**RIVERDALE PSP91 - SECTION 96A PLANNING PERMIT APPLICATION
CORNER OF LEAKES AND DAVIS ROADS TARNEIT
SUBMISSION OF AMENDED PLANS**

**RE: RIVERDALE DEVELOPMENT, TARNEIT – AMENDED 96A APPLICATION PLANS
 REVIEW OF NORTH-SOUTH CONNECTION BICYCLE INFRASTRUCTURE**

96A Application
Leakes and Davis Road, Tarneit
 JOB CODE: 1003
 CONCEPT 08
 DATE: 26/04/2013
 DRAFT: ROS

Figure 1: Growth Areas Authority (GAA) 'Standard' Residential Connector Road Cross Section

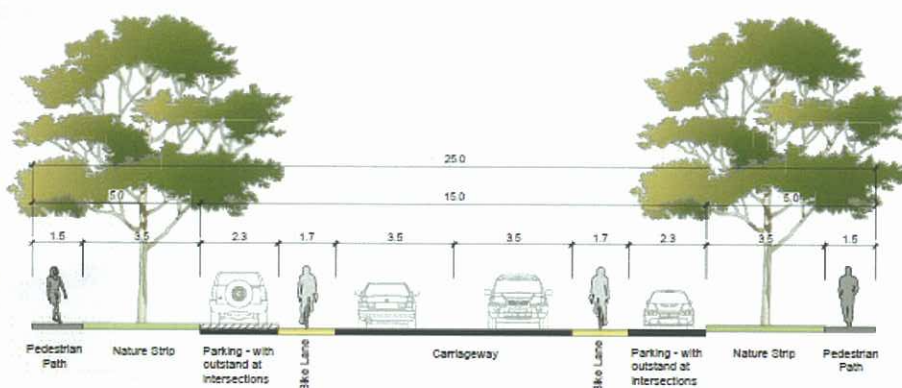
In addition, it is understood that GAA has requested the inclusion of on-road bicycle lanes on the north-south Connector Road (street typology 'Street 2') that connects Leakes Road to the east-west Connector Road. For reference the 'standard' GAA Cross Section for a Connector Road is reproduced below in Figure 1. The current cross section for the north-south Connector Road does not include any on-road bicycle paths, and incorporates 3.5m trafficable lanes, plus parking lanes.

Notwithstanding, the small section to the north between the creek path and Leakes Road does not provide designated bicycle paths. Nonetheless, the current provision of a 3.5m traffic lane can satisfactorily accommodate the anticipated low number of 'local' bicycle trips that could be expected to be generated in this area.

In the event that bicycle lanes on the north-south Connector Road is considered necessary by GAA, a suitable compromise may include the provision of alternate 4.2m wide trafficable lanes,

Figure 4: Riverdale Bicycle Route Connections

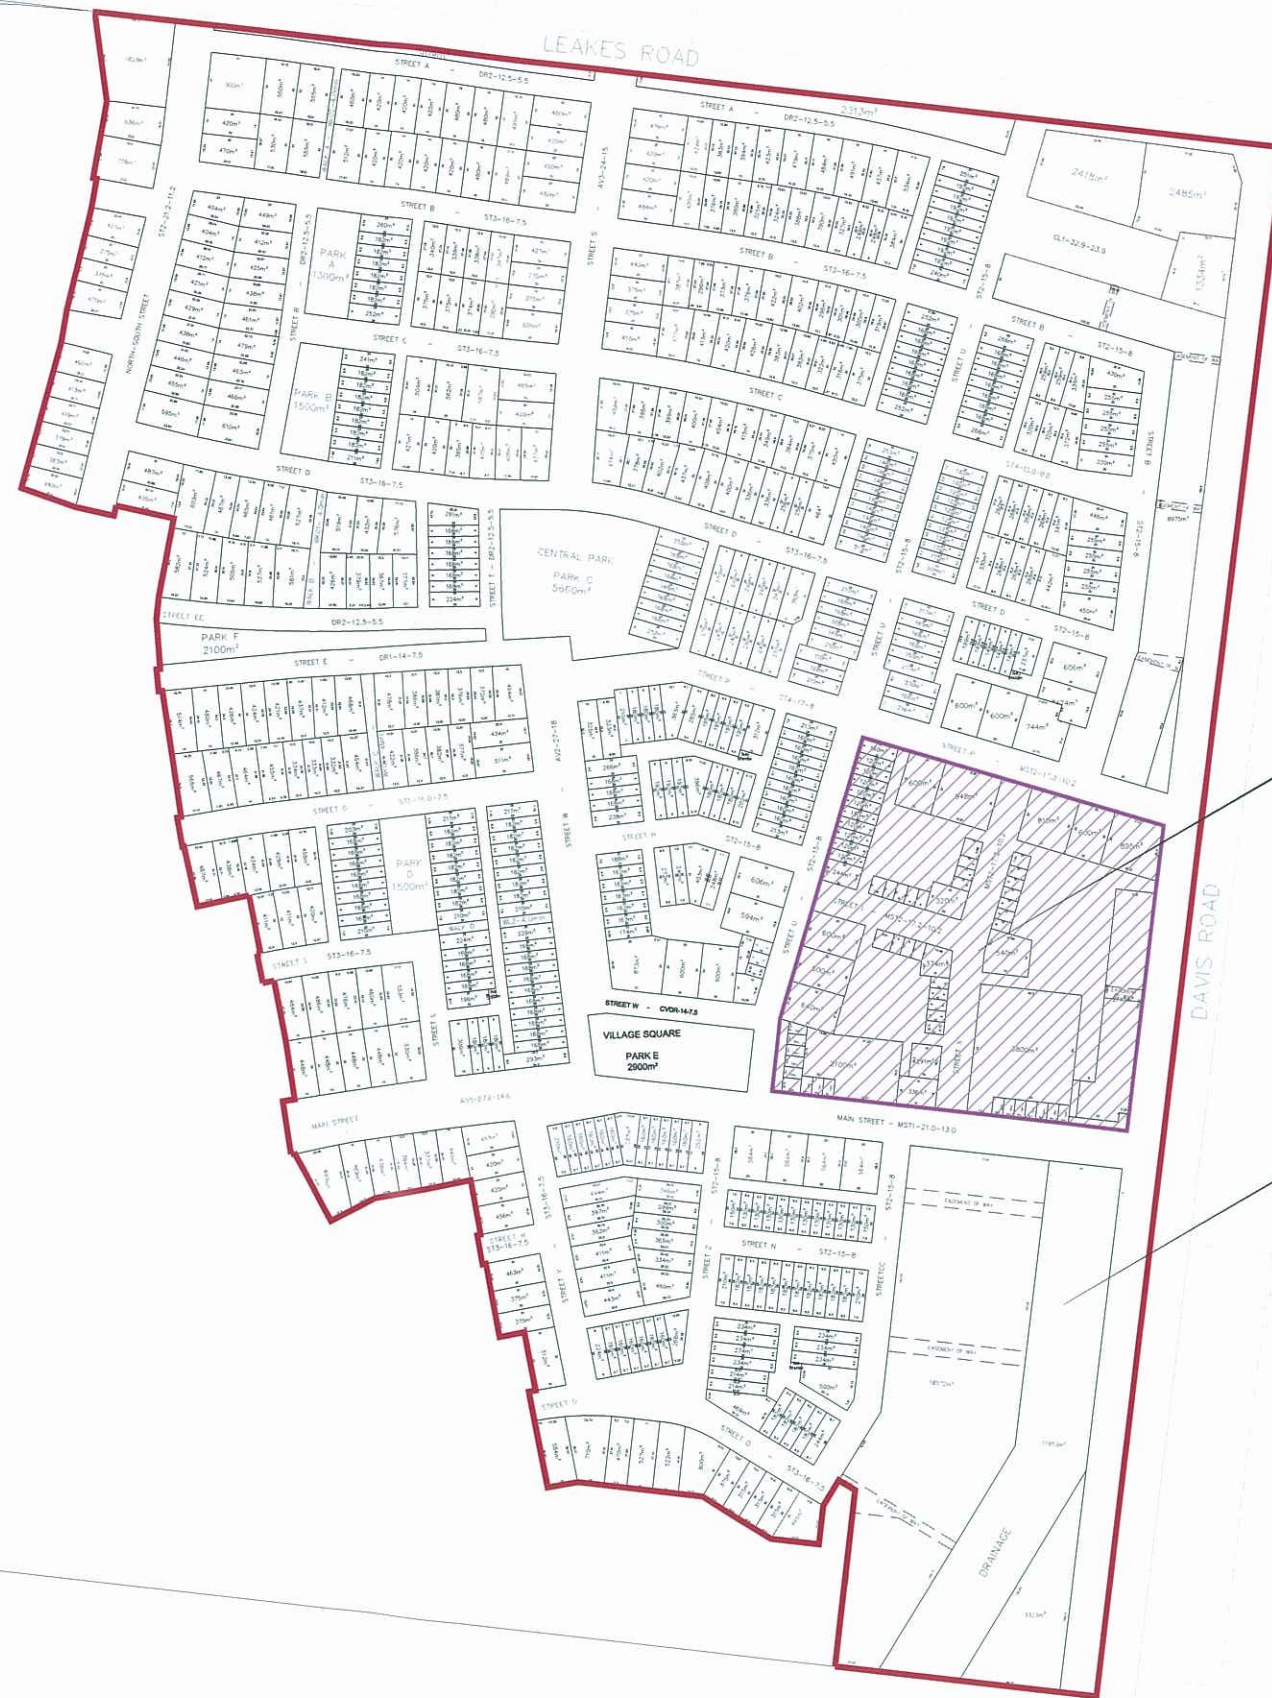
The current 96A Application plans include the provision of shared path(s) aligned along the creek reserve running north-west to south-east on the western portion of the site, as shown in Figure 4 below. It is understood that connections will be provided to the future Leakes Road shared path (or dedicated bicycle 'commuter' path). The creek shared path(s) will continue and connect to the existing PBN aligned along the future railway reserve.

Moreover, the creek bicycle path shares a similar alignment to the majority of the north-south Connector Road. As such it is considered excessive to provide a further on-road bicycle lane in this section.

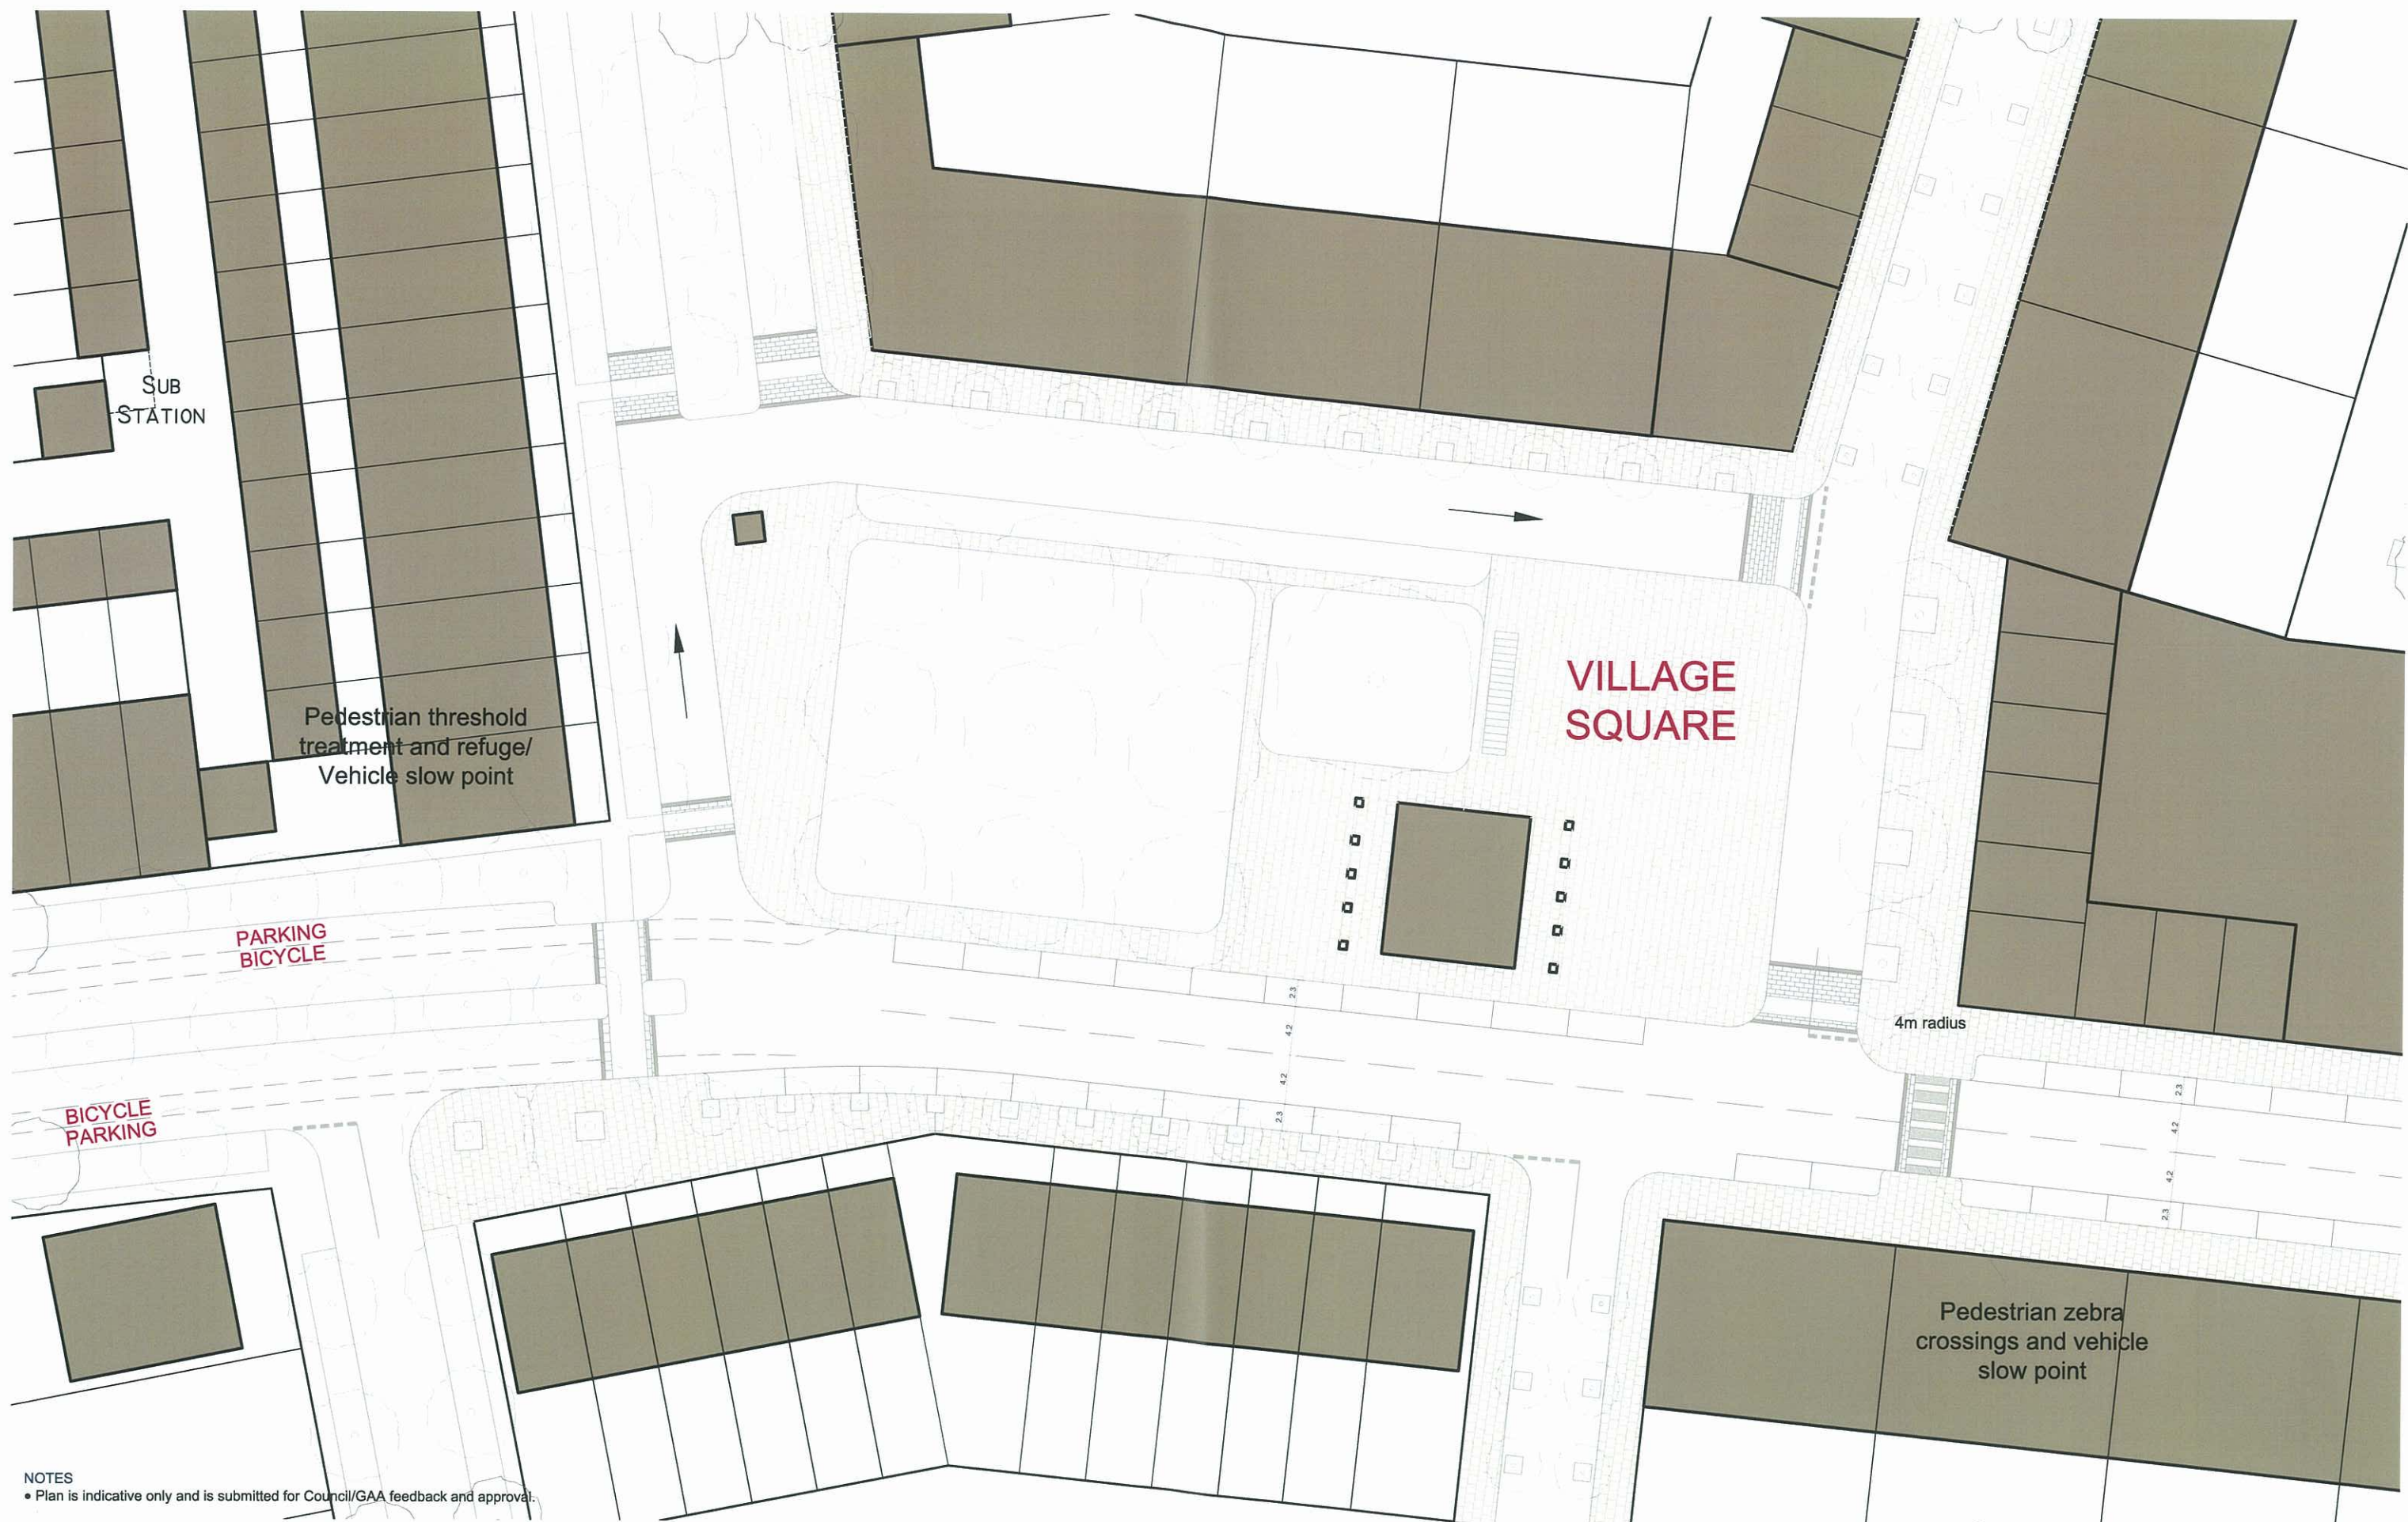
- Main Street on the plan of subdivision has been updated to provide 4.2m traffic lanes.
- Main Street on the plan of subdivision has been updated to provide 2.3m indented parking to meet PTV requirements. The total width of Main Street has been updated to 21m (MS1-21-11.2).
- Main Street will include traffic measures to ensure a speed limit of 30-40kph.

- Nature strips have been increased to 3.5m on either side. The total width of Avenue 1 has been updated to 27.6m (AV1-26.7-14.6).
- Avenue 1 will include traffic measures to ensure a speed limit of 50kph.
- Intersection transition details have been prepared and will be provided with further detailed plans.

- Nature strips have been increased to 3.5m on either side. The total width of Street 1 has been updated to
- Street 1 will include traffic measures to ensure a speed limit of 50kph.

- Nature strips have been increased to 3.5m on either side. The total width of Street 2 has been updated to 21.2m.
- Street 2 will include traffic measures to ensure a speed limit of 50kph.

You will also note that in response to the various meetings, further reporting by Neil Craigie and the submission of the 'as constructed' creek reserve in the south east corner of our site, we have updated the creek width to 40m. This width includes the required shared paths on either side of the creek.
